aseXML Schema Change Request

Document ID	37
Title	High Speed Monitoring (HSM) additions
Change Type	New transactions and supporting types
Date	10 September 2008
Prepared By	Pius Kurian

Figure 2-1 ElectricityHSMMonitorDataRequestData

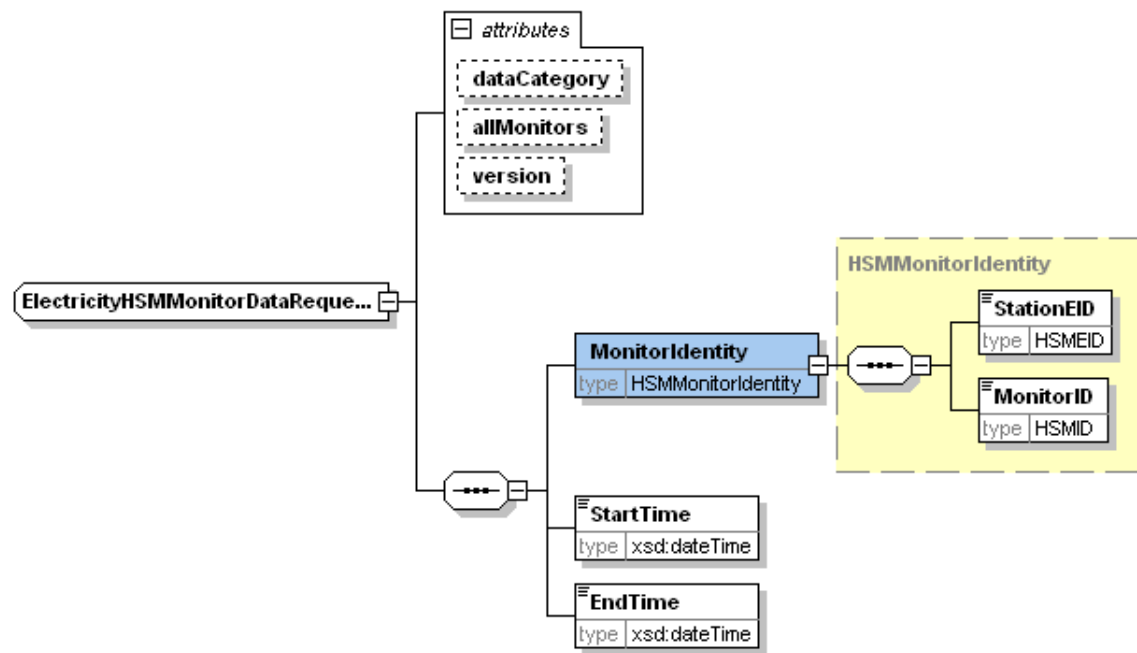
Chg #	Item #	Description of change	Filename
1	1	Add a nillable element HSMMonitorIdentities as choice to ElectricityHSMMonitorDataRequestData in ElectricityHighSpeedMonitoring_r24.xsd file	ElectricityHighSpeedMonitoring
	2	Add an optional attribute 'allMonitors' for ElectricityHSMMonitorDataRequestData in ElectricityHighSpeedMonitoring_r24.xsd file	ElectricityHighSpeedMonitoring
	3	Add a nillable element TriggeredData as choice to ElectricityHSMMonitorDataResponseData in ElectricityHighSpeedMonitoring_r24.xsd file	ElectricityHighSpeedMonitoring
2	1	Modify the Enumeration to specify the transaction types	Enumeration
3	1	Add new include elements for HighSpeedMonitoring and ElectricityHighSpeedMonitoring to schema element	aseXML
4	1	Add new type 'r24' for new schema version	Events

Text added is given in bold:

<xsd:complexType name="ElectricityHSMMonitorDataRequestData">
  <xsd:complexContent>
    <xsd:extension base="HSMMonitorDataRequestData">
      <xsd:sequence>
        <xsd:element name="MonitorIdentity" type="HSMMonitorIdentity"
nillable="true"/>
        <xsd:element name="StartTime" type="xsd:dateTime"/>
        <xsd:element name="EndTime" type="xsd:dateTime"/>
      </xsd:sequence>
      <xsd:attribute name="dataCategory" use="optional"
default="ContinuousData">
        <xsd:simpleType>
          <xsd:restriction base="xsd:string">
            <xsd:enumeration value="ContinuousData"/>
            <xsd:enumeration value="TriggeredData"/>
          </xsd:restriction>

</xsd:simpleType>
    </xsd:attribute>
    <xsd:attribute name="version" type="r24" default="r24"/>
    <xsd:attribute name="allMonitors" type="xsd:boolean" use="optional"/>
    </xsd:extension>
    </xsd:complexContent>
</xsd:complexType>
<xsd:complexType name="ElectricityHSMMonitorDataResponseData">
    <xsd:complexContent>
        <xsd:extension base="HSMMonitorDataResponseData">
            <xsd:sequence>
                <xsd:choice>
                    <xsd:element name="ContinuousData" type="HSMMonitorData"
nillable="true"/>
                    <xsd:element name="TriggeredData"
type="HSMMonitorData" nillable="true"/>
                </xsd:choice>
            </xsd:sequence>
            <xsd:attribute name="version" type="r24" default="r24"/>
        </xsd:extension>
    </xsd:complexContent>
</xsd:complexType>
